REMARKS

Appl. No. 10/041,597
Amdt. dated October 6, 2004
Reply to Office Action of June 4, 2004

FIG. 3

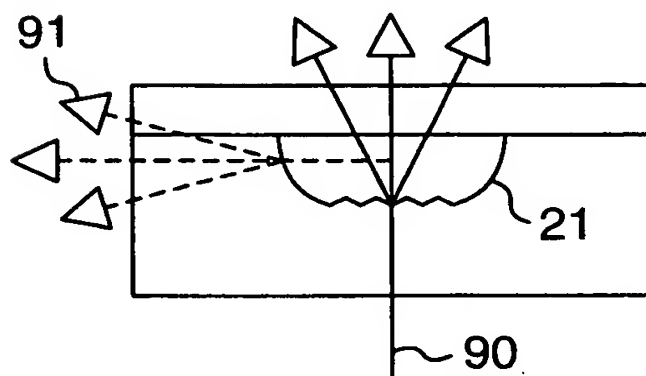
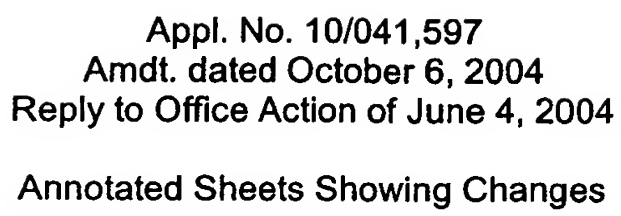
The drawings have been objected to because FIG. 3 is not designated by a legend such as "Prior Art." However, this objection is incorrect. FIG. 3 is not believed to constitute "prior art" as that term is defined by either 35 U.S.C. §102 or 35 U.S.C. §103. Rather, FIG. 3 is simply an abstract representation of the art prepared by Applicants in an effort to illustrate Applicants' discovery of problems plagued in the art; this discovery is itself, together with Applicants' abstraction of the art represented by FIG. 3, part of Applicants' invention. FIG. 3 is therefore, Applicants' work products and Applicants' effort to describe his invention in terms of both the problems which have plagued in the art and which Applicants have addressed with the inventions defined by the claims. In view of these explanations, Applicants again trust that the objection will be withdrawn. Nevertheless, for purposes of expedition, FIG. 3 has been labeled as "Related Art" in order to place the application in condition for allowance.

RELATED ART
